Chapter 2

Comments Received on the Draft EIR

Subject: General Permit for Site-wide Groundwater Remediation Project
SCH#: 2008011097

FIGURE 1
IRZ Manganese Data Distribution
(Displayed data was obtained from 3 different sources: PG&E, Nick Grill et al. and Water Board)

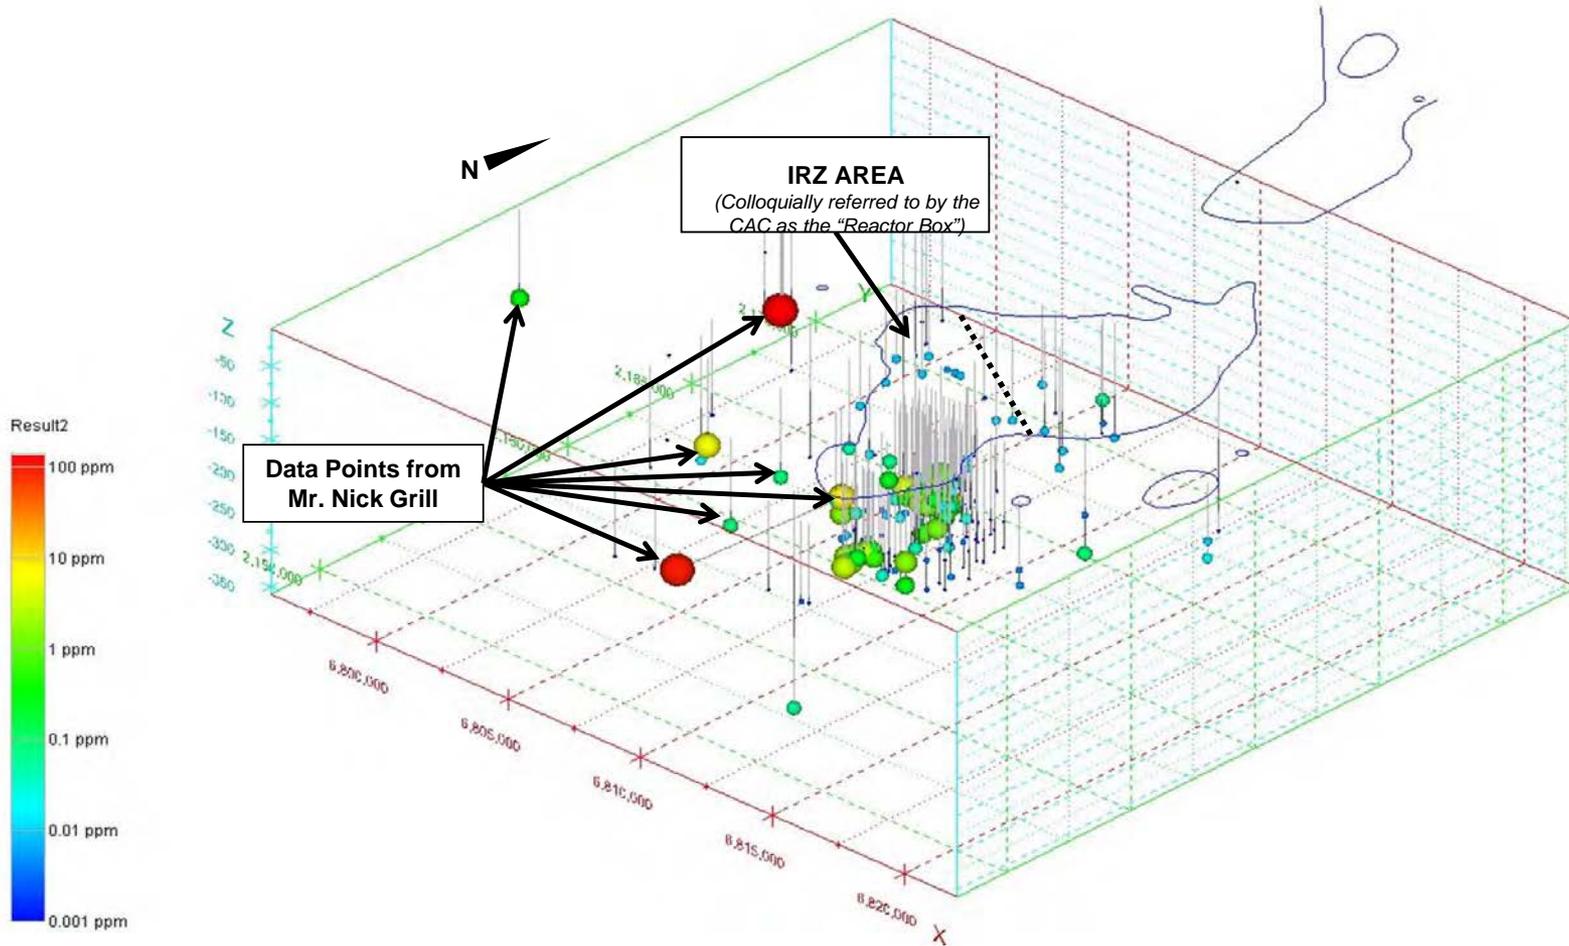
From an IRP Manager’s perspective, taken at face value, and with no knowledge about the accuracy of the sampling exercise, Mr. Grill’s highest magnitude data points (provided in **Figure 2**) display as the two (red colored) western data points in Figure 1. Such observations, implying a release of manganese beyond the bounds of the IRZ and the Cr6 plume boundary (also supported by anecdotal comments made by other community members at the CAC monthly meetings) causes the CAC to ask the IRP Manager to raise this issue in this EIR comments package. In addition, the IRP Manager has overlain the IRZ manganese Figure from the EIR over the aforementioned 3D data display, and the result is shown in **Figure 3**. The EIR claims that “based on available data,” there appears to be no release of Mn to the west. (Draft EIR, p.3.1-33). It should be noted, however, that EIR Figure 3.1-11 does not show any information being collected to the west side of the plume. Mr. Grill’s data appears to be one of the first manganese sampling efforts in this area. During August 2012, the Water Board also sampled some domestic wells in this area (see Figure 2), but measured manganese concentrations two to three orders of magnitude less than Mr. Grill’s measurements.

The manganese monitoring data collected by Mr. Nick Grill is provided in **Attachment B**. This is the data which is shown in Figure 2, and is plotted in Figure 1. (Figure 2 also lists Water Board collected data. The Water Board measurements are significantly less than those made by Mr. Grill).

Lower image: Also shown in Figure 1, was prepared by the IRP Manager, and includes Mr. Nick Gill's Mn data points

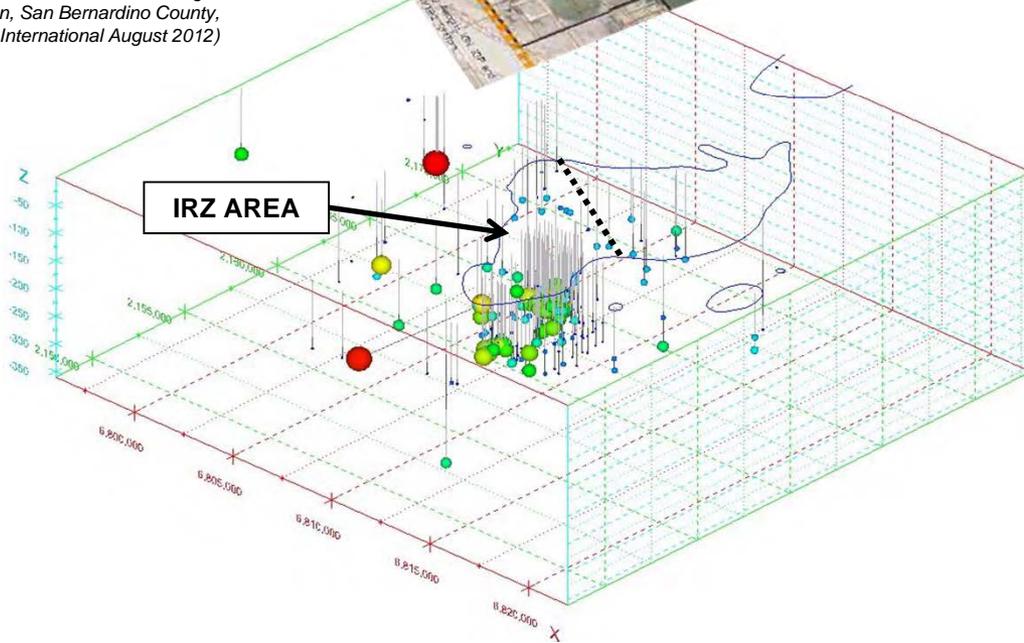
Figure 3: IRP Manager's 3D display for Manganese at the IRZ overlain with similar Manganese data displayed in a Figure from the Draft EIR.

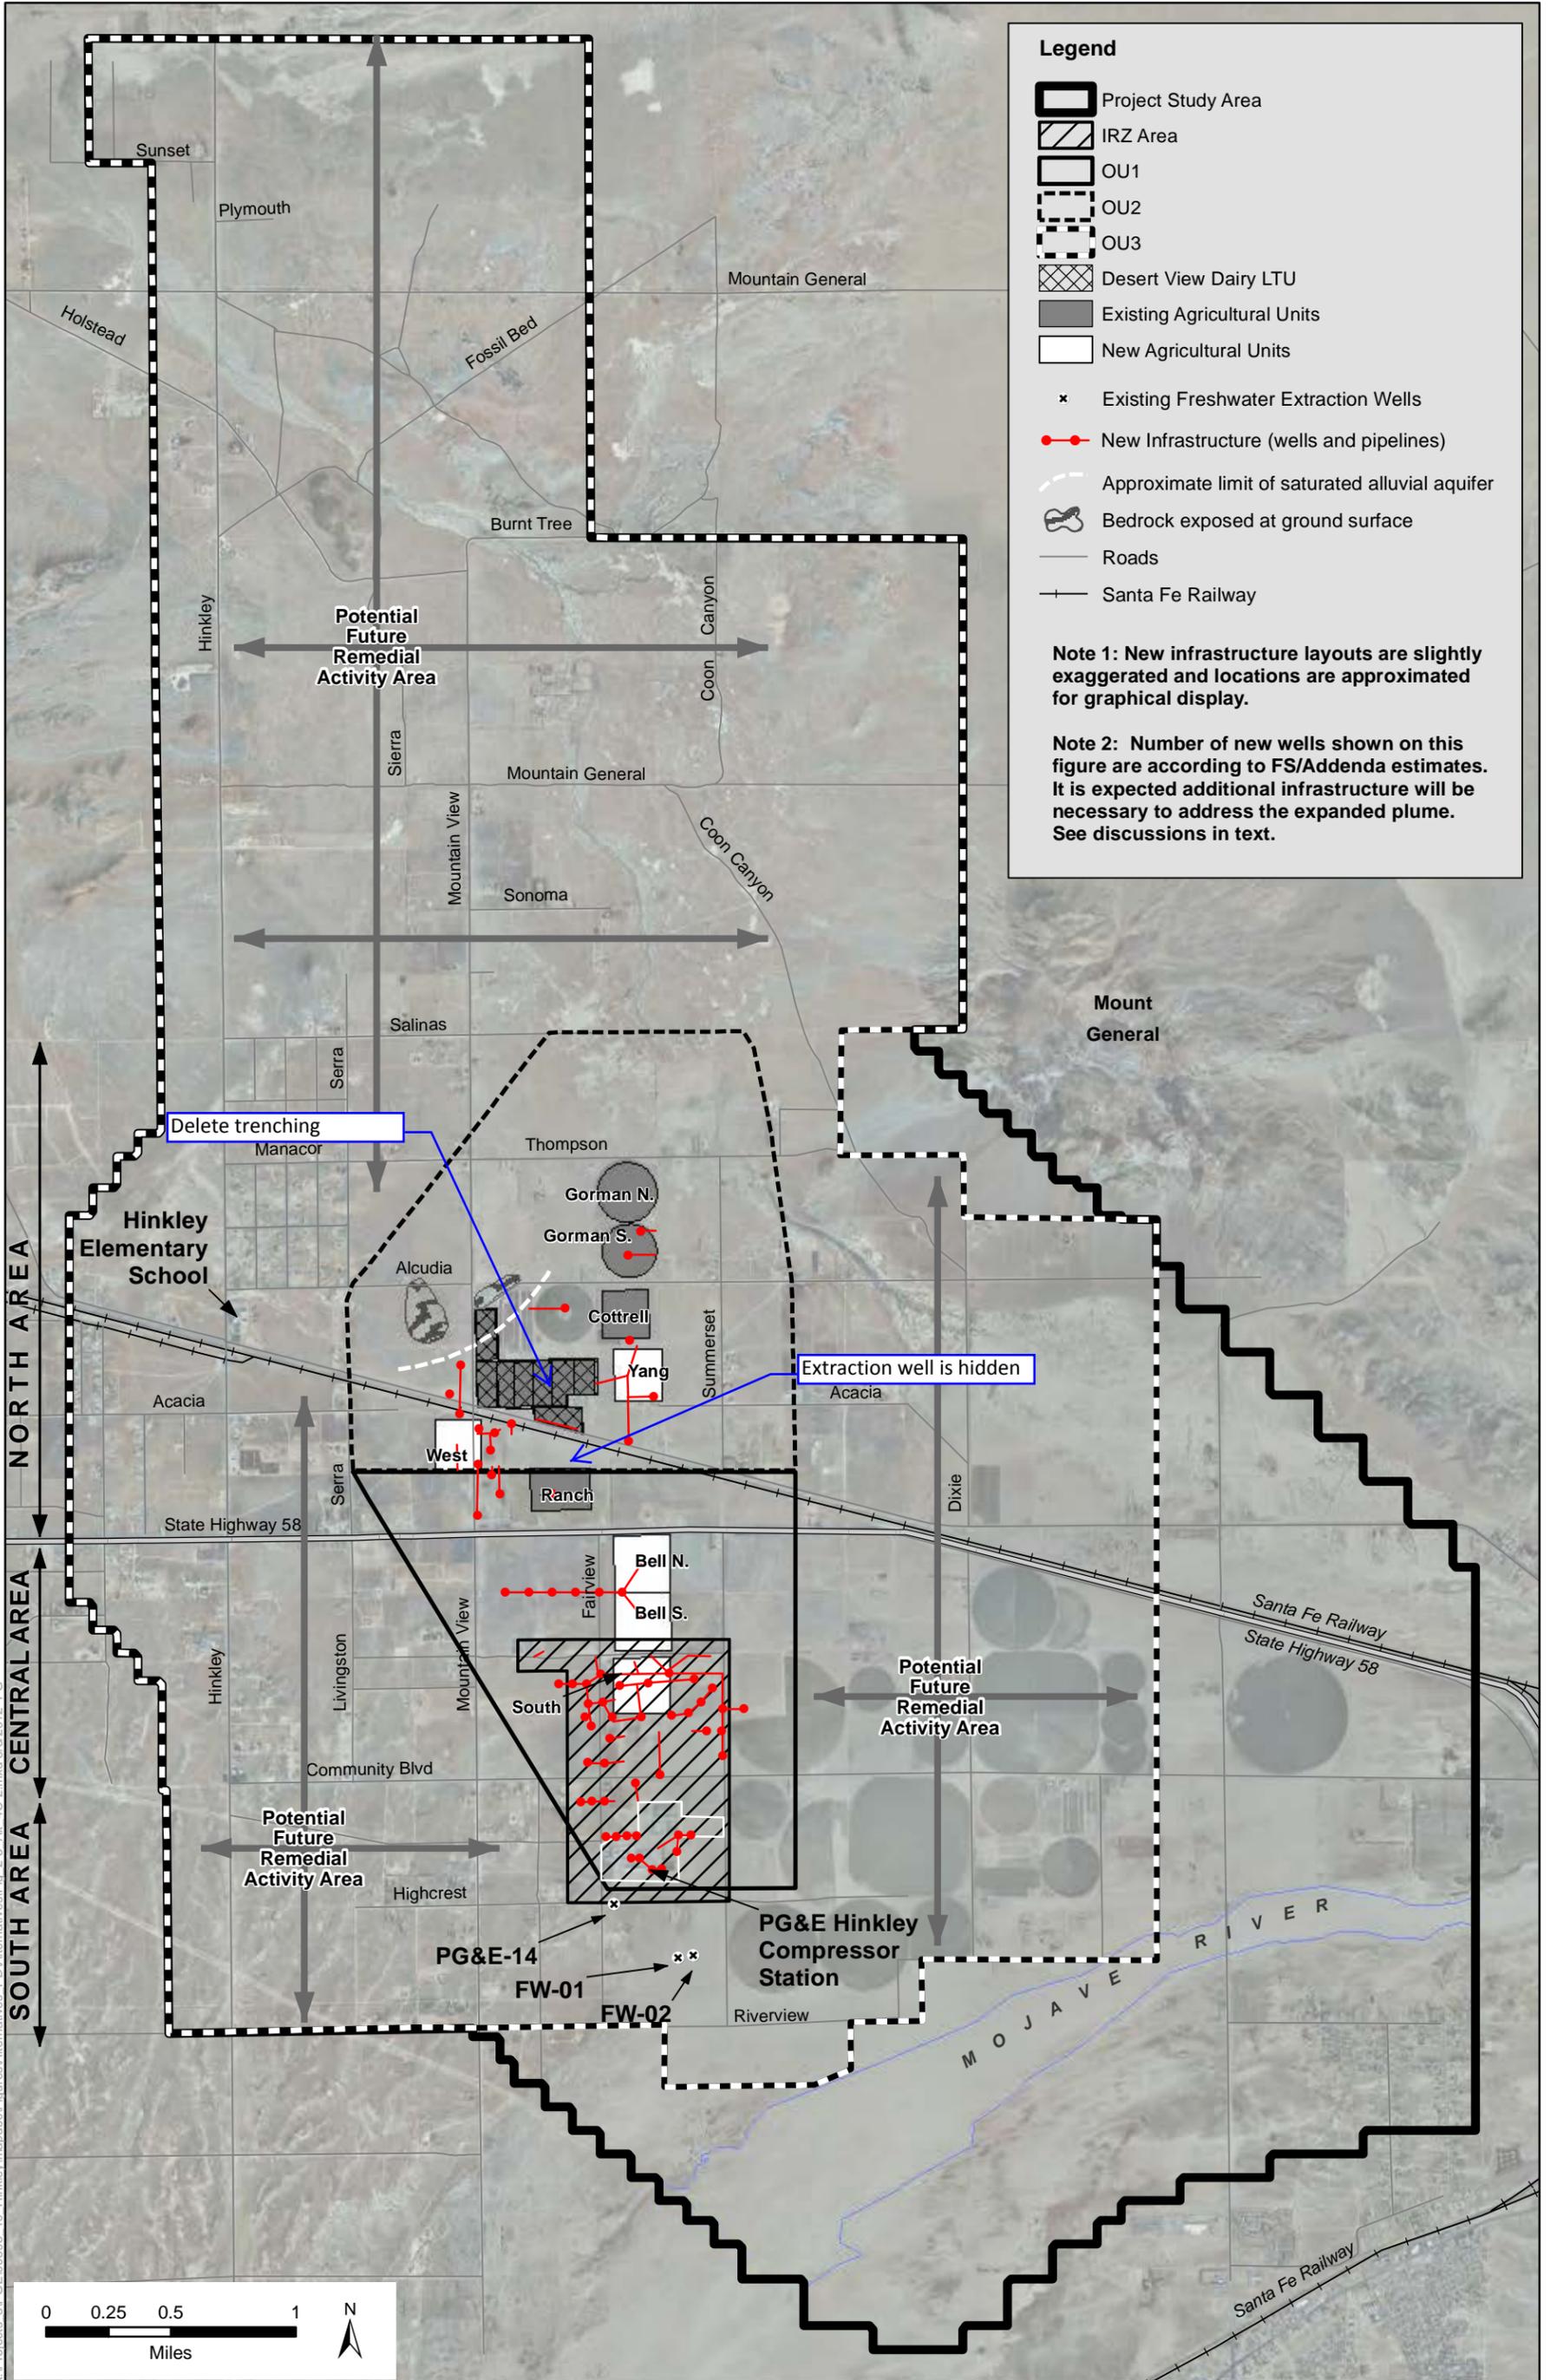
Comment [d1]: Totals are linear feet of trenching, we suggest adding a note to clarify

Comment [d2]: 140 gpm + 25% contingency

Comment [d3]: 5 + 15% contingency

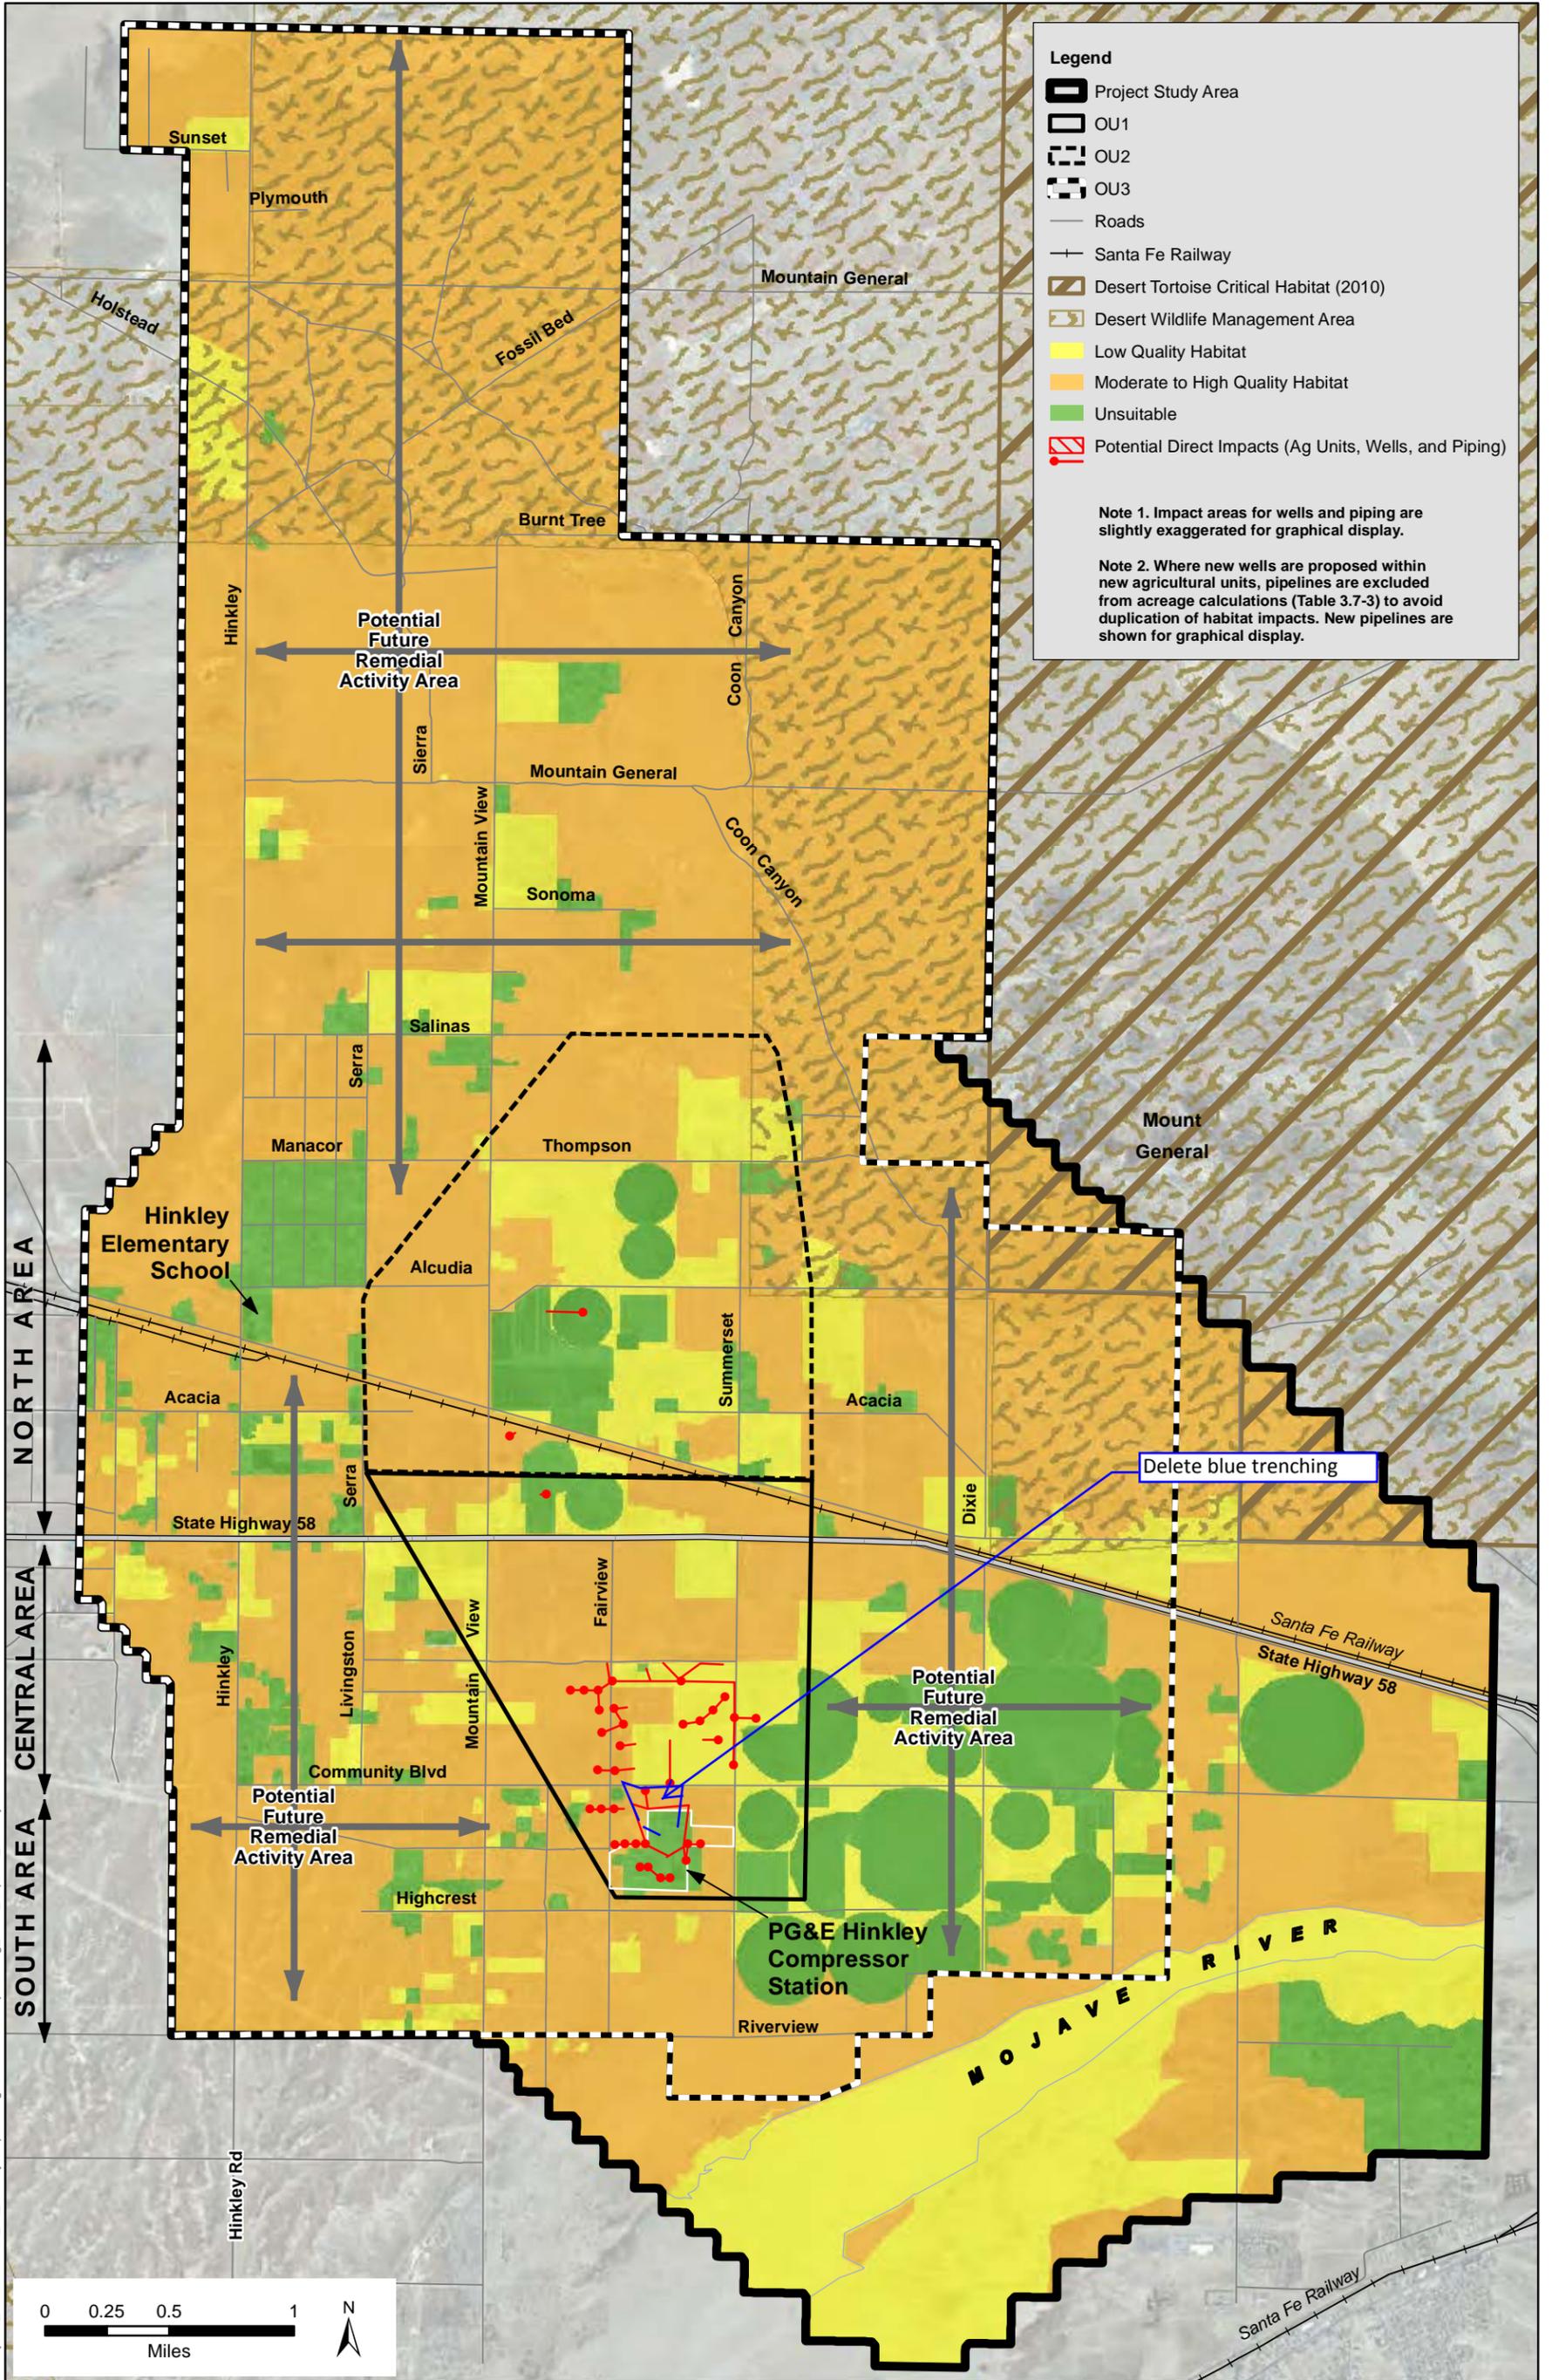
Comment [d11]: 240 VMT/month not daily

Comment [d12]: 424 VMT/month, not daily
